Tyrone Operations
P.O. Box 571
Tyrone, NM 88065

November 21, 2022

**Re: Response to Public Hearing Comments, Tyrone Mine Emma Project,
Freeport McMoRan Tyrone Inc., Revision 21-1 to Permit No. GR010RE**

Predicted Drawdown at 40 Years from Open Pit Dewatering at Emma

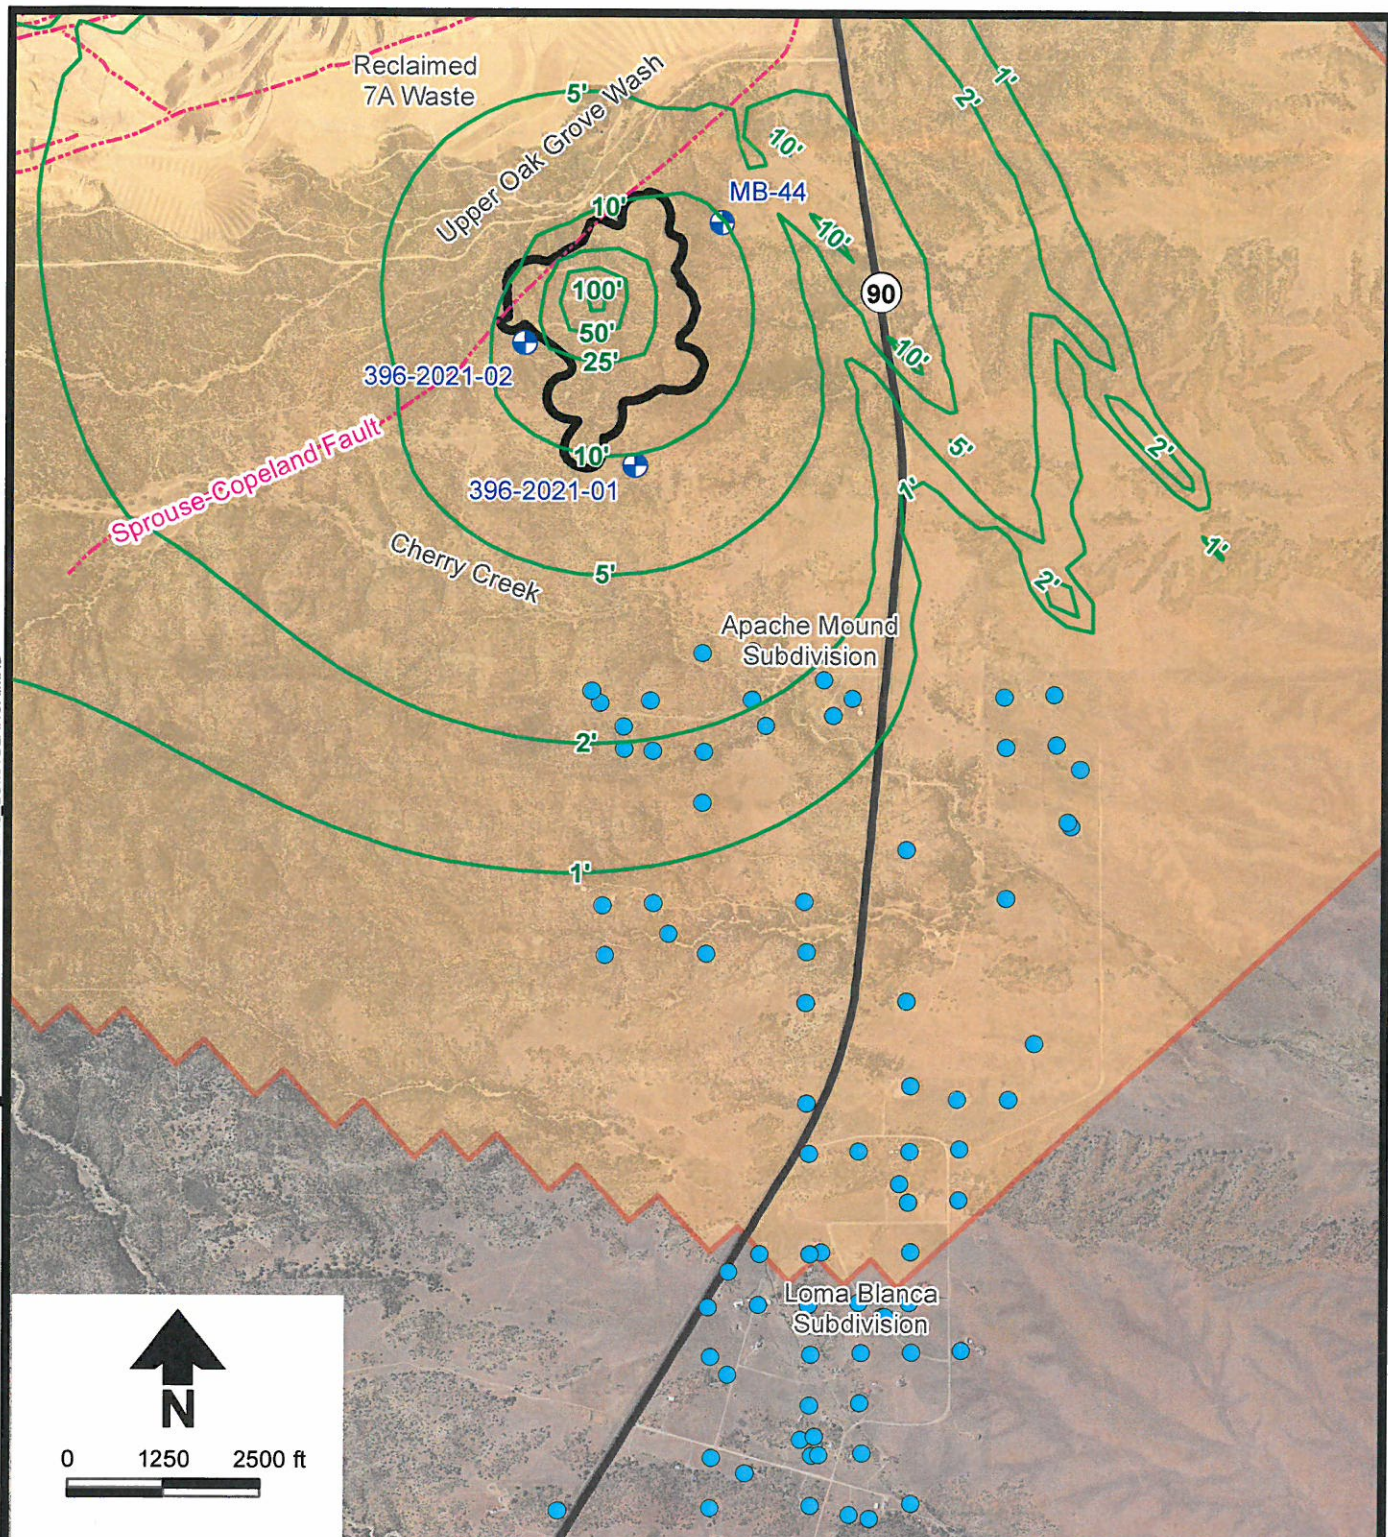
Figure 5 of Appendix G of DBS&A 2021b provides a long-term drawdown prediction for the regional aquifer. Neighbors from the Loma Blanca-Cullum subdivision (southeast of Apache Mound and significantly further away from the Emma site) requested their communities also be evaluated for drawdown. Predicted drawdown at this subdivision is less than 1 foot. While the Loma Blanca-Cullum subdivision is located just beyond the domain of the DBS&A (2021) groundwater flow model, the model simulates drawdown to 1-foot drawdown contour. The subdivision is located beyond this contour. Please see Attachment A for the figure that shows these areas.

Emma Expansion Project
Regional Groundwater Level Elevations
and Flow Direction, April 2022

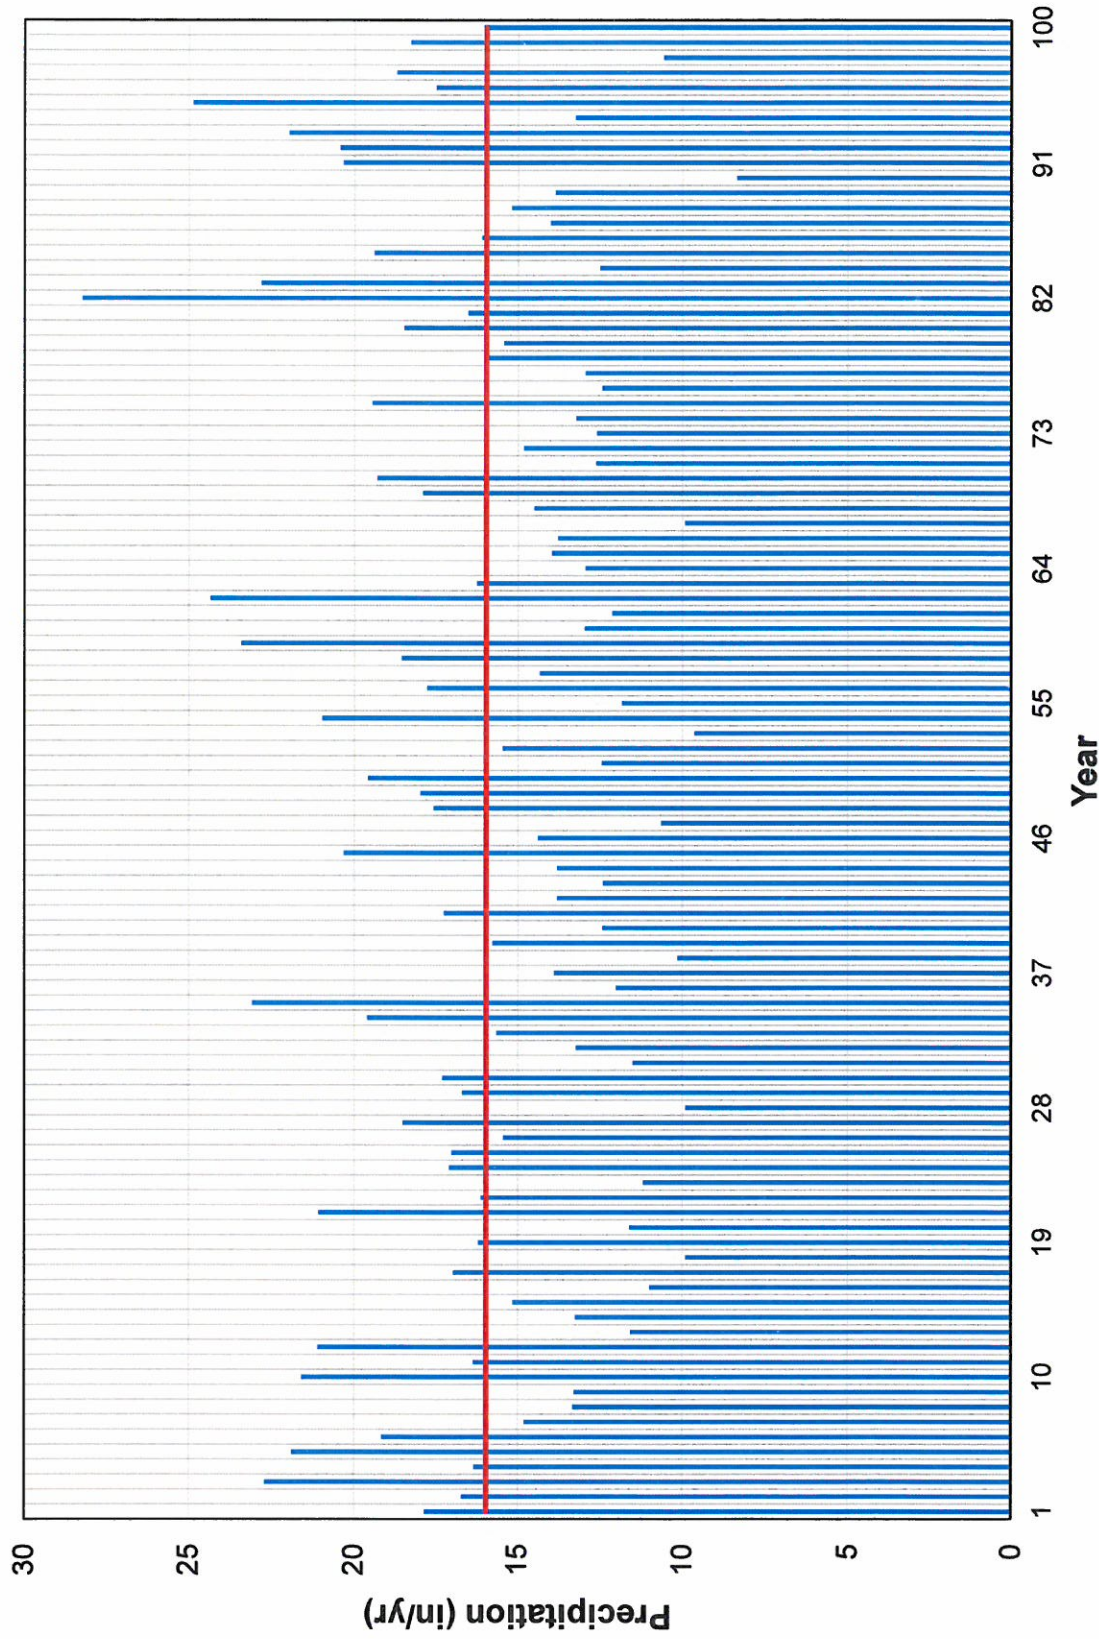
The groundwater flow direction at Emma is to the northeast and not toward the Apache Mound Subdivision (Attachment B). The Apache Mound Subdivision is cross gradient of Emma. The Emma project will not degrade the neighbors' water supply.
